AGENDA ITEM #6

RESOLUTION PC 07 47 CUP 08: REQUEST FOR APPROVAL OF A CONDITIONAL USE PERMIT TO CONSTRUCT A SEAWALL ON LOTS THREE THROUGH TEN OF MARINE MANOR PUD LOCATED BETWEEN THE SIUSLAW RIVER AND RHODODENDRON DRIVE AT SITE ADDRESSES: 3215, 3225, 3265, 3285, 3305, AND 3315 RHODODENDRON DRIVE AND LOTS 3 AND 4 OF MARINE MANOR PUD. AS APPLIED FOR BY MARINE MANOR HOME OWNERS ASSOCIATION

**STAFF REPORT AND FINDINGS
FLORENCE COMMUNITY DEVELOPMENT DEPARTMENT
Planning Commission
Exhibit "A"**

Public Hearing Date: February 5, 2008 **Planner:** Carol Heinkel
Date of Report: January 29, 2008
Application: PC 07 47 CUP 08

Typical Wall Section A-A
Scale: 3/8" = 1'-0"

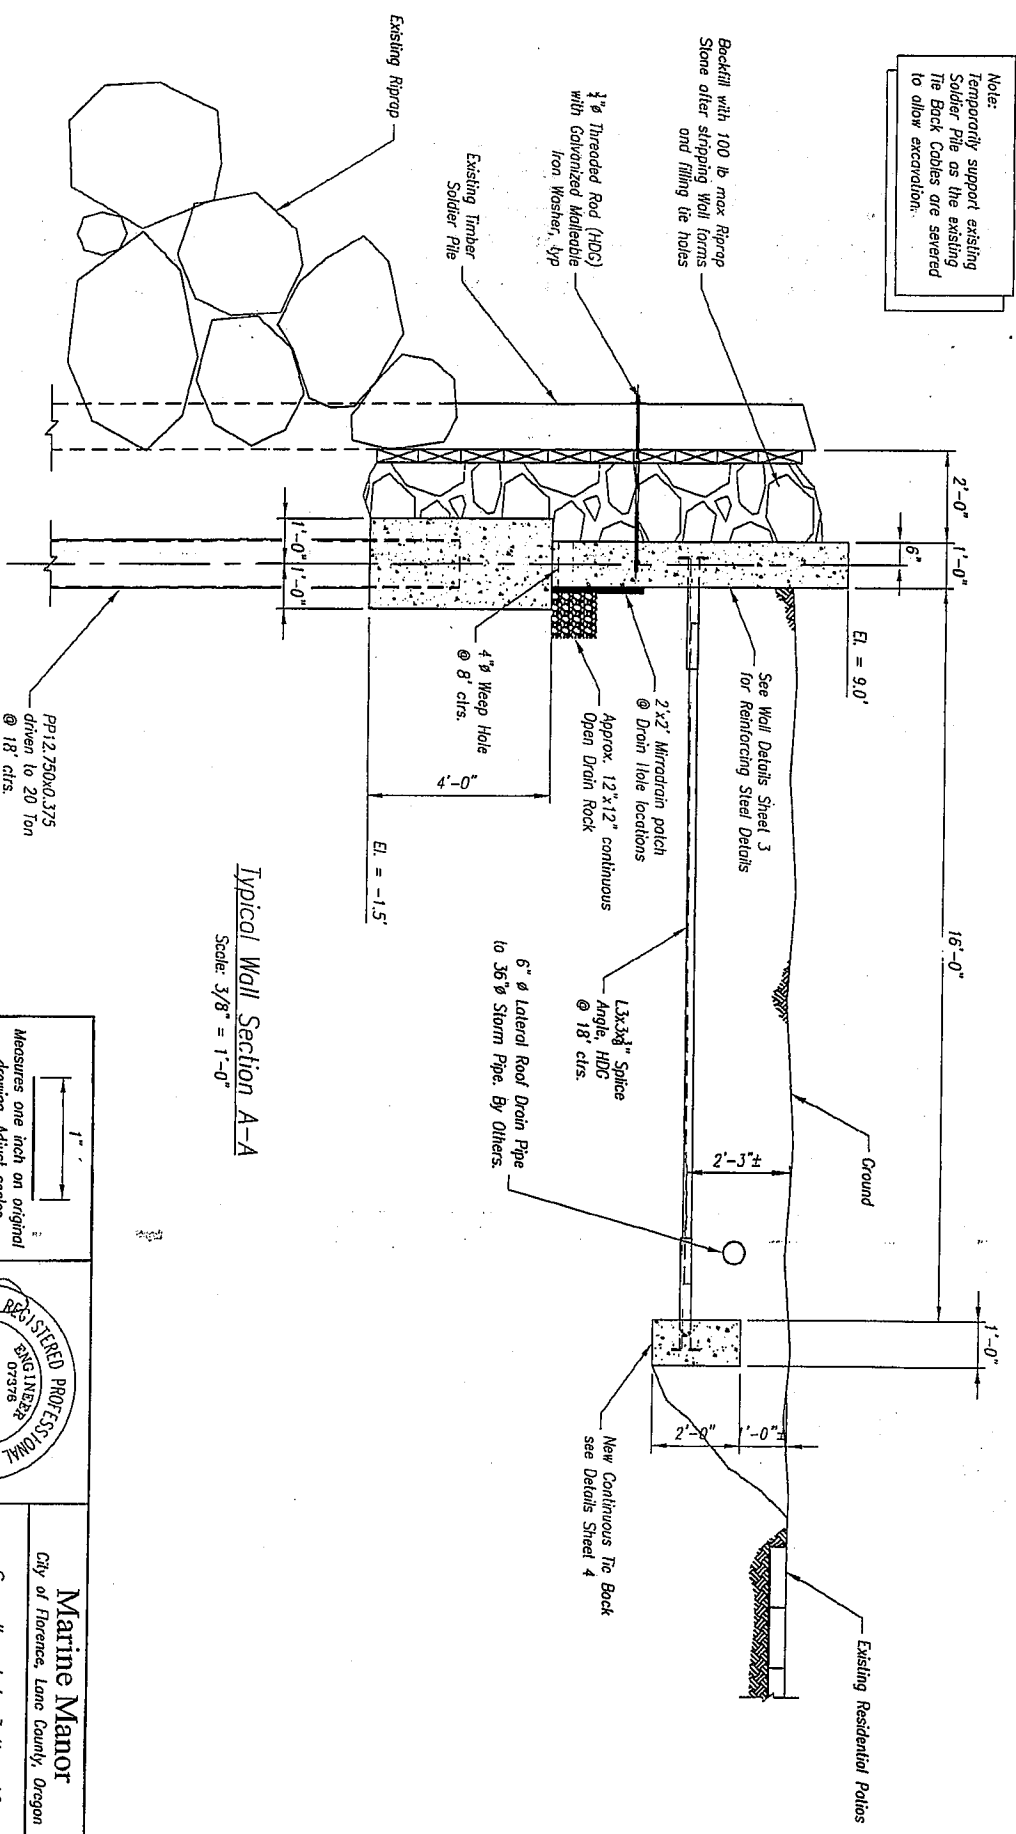
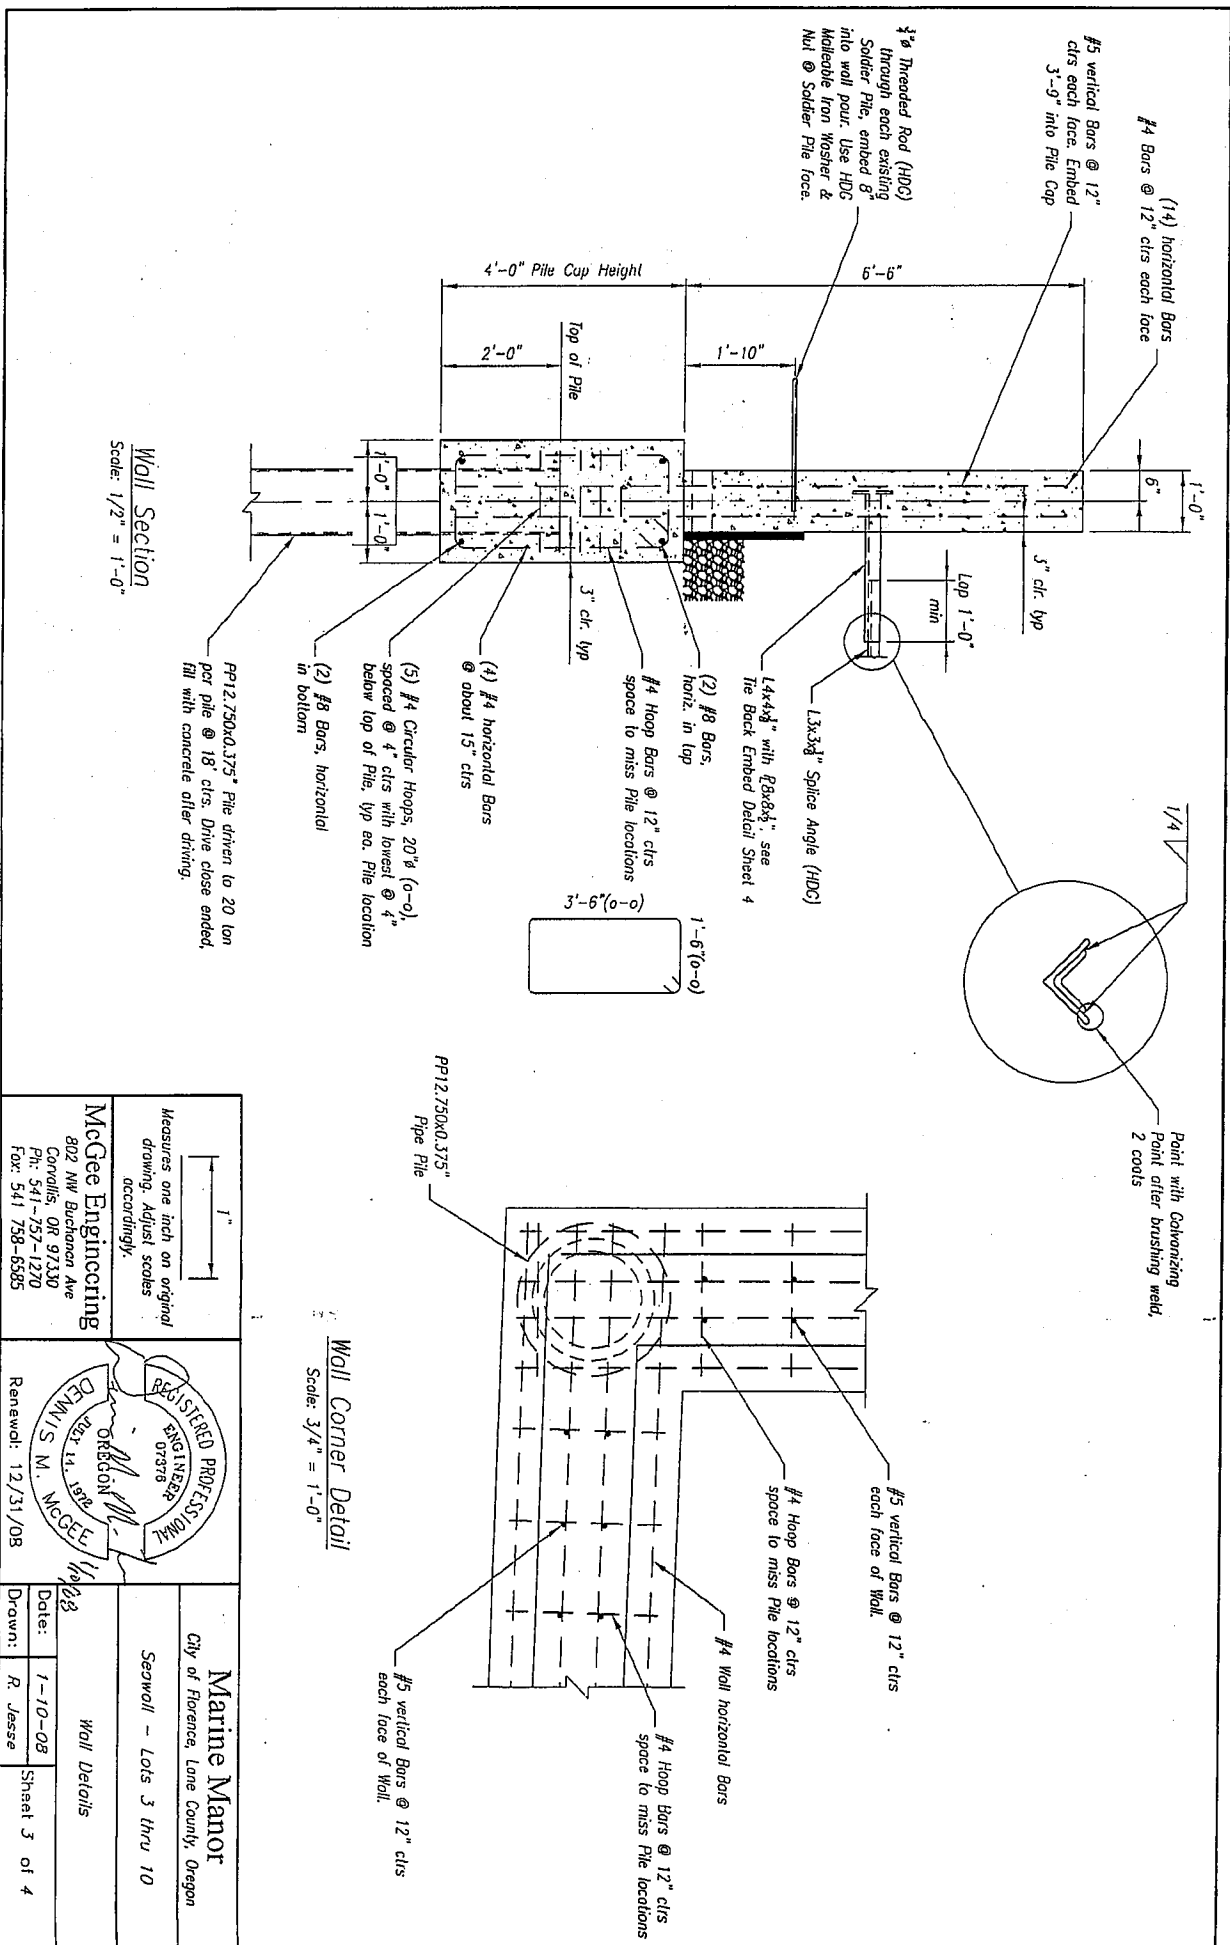
1. Documentation presented by the applicant shows the existing seawall is deteriorating and can be expected to fail in the near future. The failure will include erosion of rip rap that protects the wall and the wooden structure of the wall itself. Following failure of the existing wall, it can be expected that the Siuslaw River will remove soil from in front of the proposed replacement wall. The applicant has not provided an analysis that supports the retaining wall design with respect to scour from the Siuslaw river. The applicant should submit a scour analysis to support the design depth of embedment below the existing ground surface.

2. The Site Investigation Report does not indicate that site specific sub-surface explorations have been performed to support the structural design of the proposed retaining wall. The applicant should provide documentation in the building permit application that provides the basis for structural design of the proposed wall. The geotechnical evaluation

3. The site investigation report states the sea wall will be supported on cylindrical steel pipes to a bearing of 20 tons. The report does not include a minimum embedment depth for the piles or estimate the depth that a bearing of 20 tons will be reached. The applicant should provide minimum pile embedment depths and other typical design and construction criteria with the Building Permit application."

- a. Following failure of the existing wall, it can be expected that the Siuslaw River will remove soil from in front of the proposed replacement wall. The applicant must provide an analysis that supports the retaining wall design with respect to scour from the Siuslaw River. The applicant should submit a scour analysis to support the design depth of embedment below the existing ground surface.

- b. The applicant should provide documentation in the building permit application that site specific subsurface explorations have been performed to support the structural design of the proposed retaining wall and provide the basis for structural design of the proposed wall. The geotechnical evaluation should assume that soil is removed from the front face of the wall to the design scour depth.

- c. The applicant should provide minimum pile embedment depths and other typical design and construction criteria with the Building Permit application. The site investigation report states the sea wall will be supported on cylindrical steel pipes to a bearing of 20 tons. The report does not include a minimum embedment depth for the piles or estimate the depth that a bearing of 20 tons will be reached.
